Subject: Official Notice No. 117-1-2016

Police Administration Building, 3rd Floor
Demolition & Asbestos Abatement
749 West State Street
Milwaukee, Wisconsin

Addendum No. 1

2ND FLOOR ASBESTOS ABATEMENT PLAN
 1/8" = 1'
 NORTH

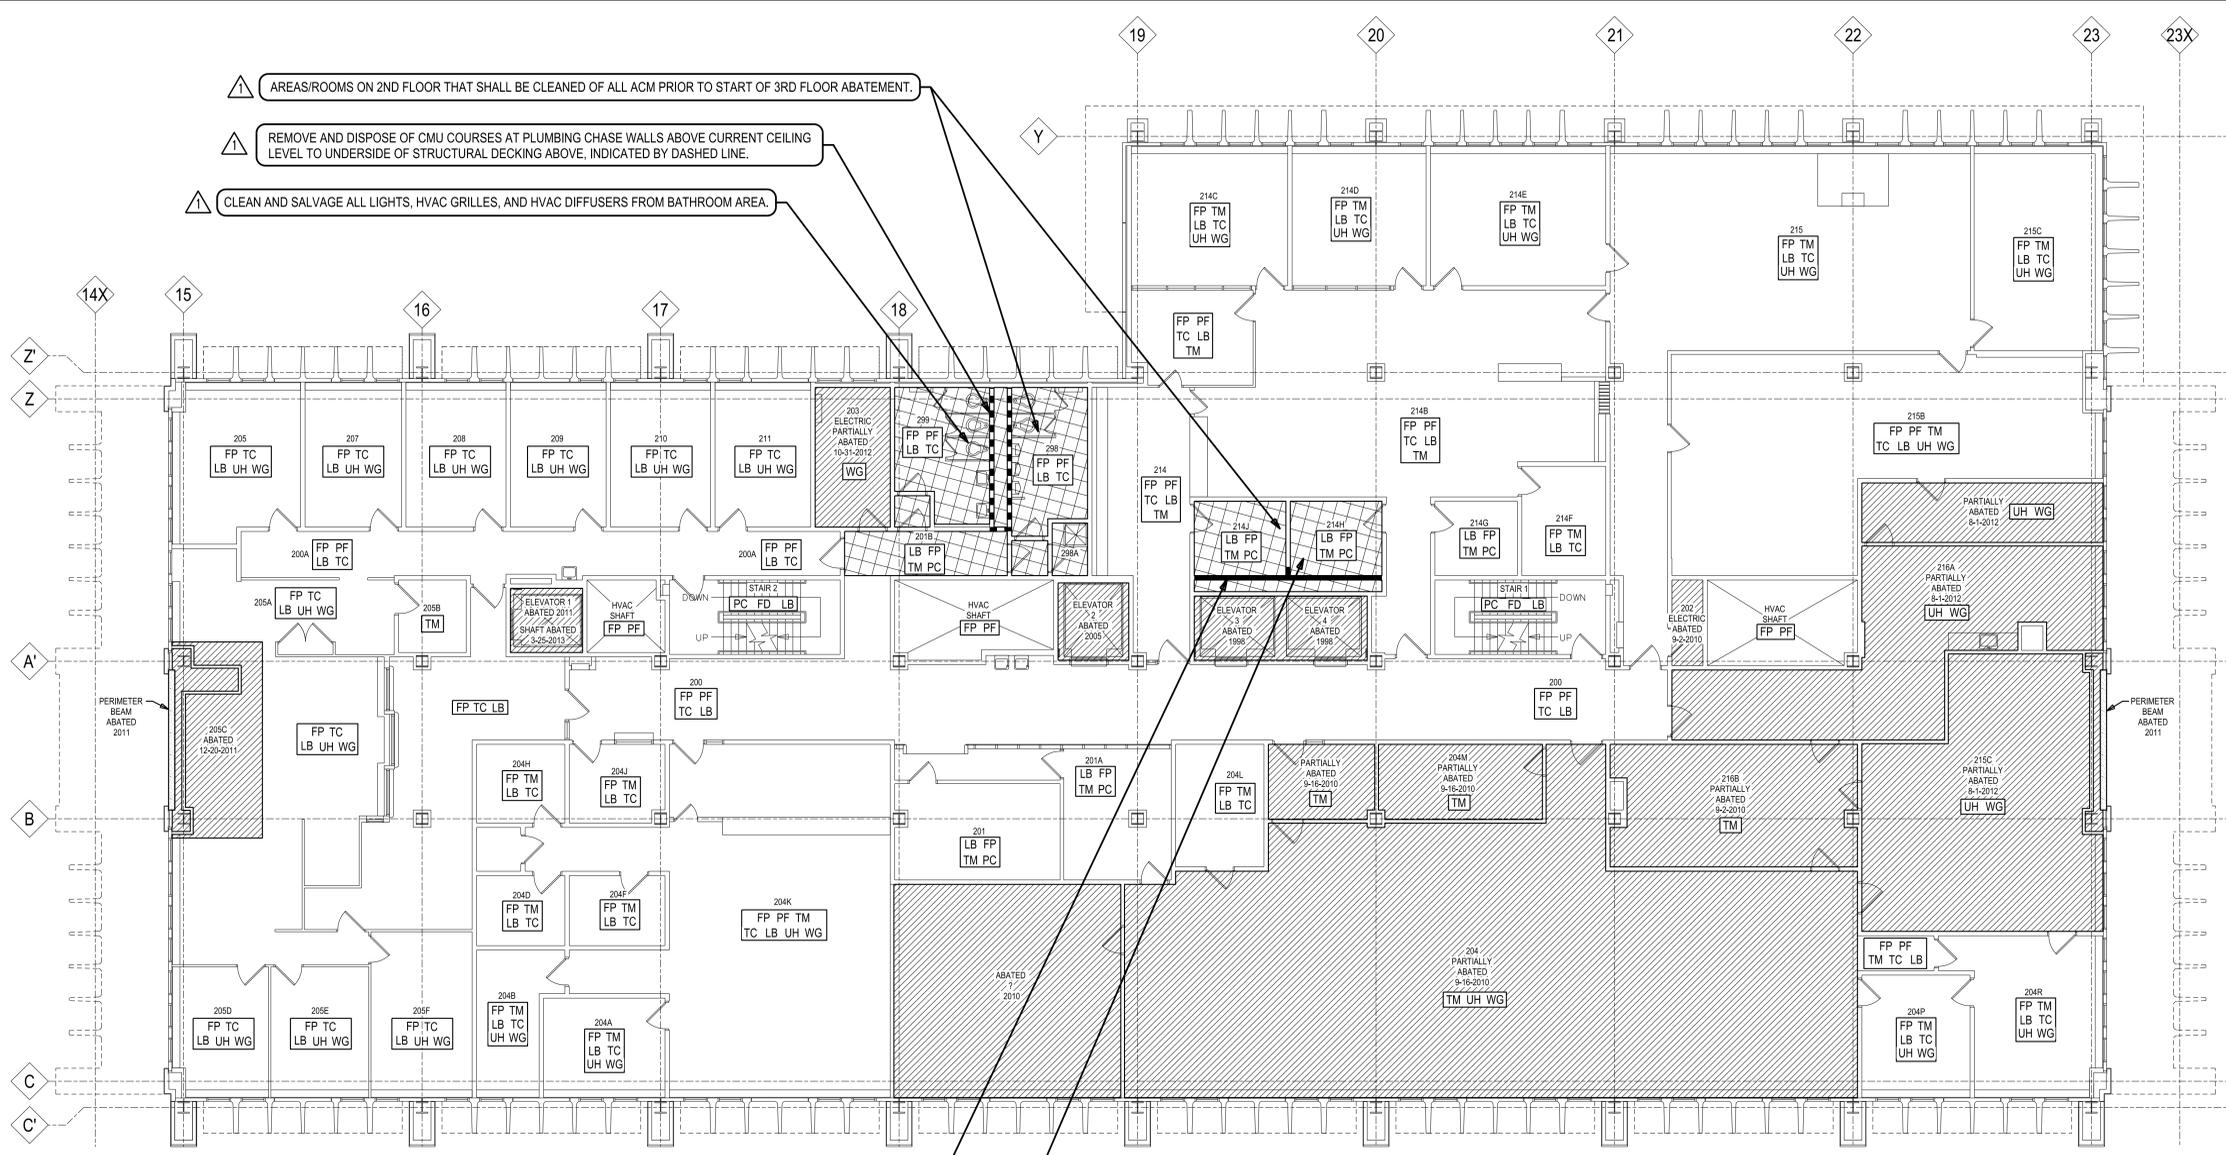
REPLACE the Original contract drawing M-3 with M-3 (Addendum #1)

△ AREAS/ROOMS ON 2ND FLOOR THAT SHALL BE CLEANED OF ALL ACM PRIOR TO START OF 3RD FLOOR ABATEMENT.

△ REMOVE AND DISPOSE OF CMU COURSES AT PLUMBING CHASE WALLS ABOVE CURRENT CEILING LEVEL TO UNDERSIDE OF STRUCTURAL DECKING ABOVE, INDICATED BY DASHED LINE.

△ CLEAN AND SALVAGE ALL LIGHTS, HVAC GRILLES, AND HVAC DIFFUSERS FROM BATHROOM AREA.

△ REMOVE AND DISPOSE OF CMU WALLS AT PLUMBING CHASE FROM 2ND FLOOR LEVEL TO UNDERSIDE OF STRUCTURAL DECKING ABOVE, INDICATED BY SOLID BLACK LINE. DURING ABATEMENT, INSTALL SEPARATION BARRIER BETWEEN ABATED AND NON-ABATED AREAS.

△ REMOVE AND DISPOSE OF ALL LIGHTS, HVAC GRILLES, AND HVAC DIFFUSERS FROM ROOMS BEHIND ELEVATORS 3 & 4.

3. THE A.C. SHALL REMOVE AND DISPOSE OF CMU COURSES AT PLUMBING CHASE WALLS ABOVE CURRENT CEILING LEVEL TO UNDERSIDE OF STRUCTURAL DECKING ABOVE IN 2ND FLOOR BATHROOM AREA.

4. THE A.C. SHALL REMOVE AND DISPOSE OF CMU WALLS AT PLUMBING CHASE FROM 2ND FLOOR LEVEL TO UNDERSIDE OF STRUCTURAL DECKING ABOVE, INDICATED BY SOLID BLACK LINE. DURING ABATEMENT, A.C. SHALL INSTALL SEPARATION BARRIER BETWEEN ABATED AND NON-ABATED AREAS.

5. THE A.C. SHALL REMOVE AND DISPOSE OF SUSPENDED ACOUSTICAL CEILING IN 2ND FLOOR BATHROOM AREA.
 6. THE A.C. SHALL REMOVE AND DISPOSE OF SPRAY-ON FIREPROOFING, THERMAL SYSTEMS INSULATION (TSI) FROM HVAC DUCTWORK AND PIPING IN ALL AREAS TO BE ABATED ON 2ND FLOOR. A.C. SHALL REINSULATE PIPING AND DUCTWORK IN ALL AREAS TO BE ABATED ON 2ND FLOOR.

7. THE A.C. SHALL CLEAN AND SALVAGE ALL LIGHTS, HVAC GRILLES, AND HVAC DIFFUSERS FROM 2ND FLOOR BATHROOM AREA.
 8. THE A.C. SHALL REMOVE AND DISPOSE OF ALL LIGHTS, HVAC GRILLES, AND HVAC DIFFUSERS FROM ROOMS BEHIND ELEVATORS 3 & 4 AND PLUMBING CHASE ON 2ND FLOOR.
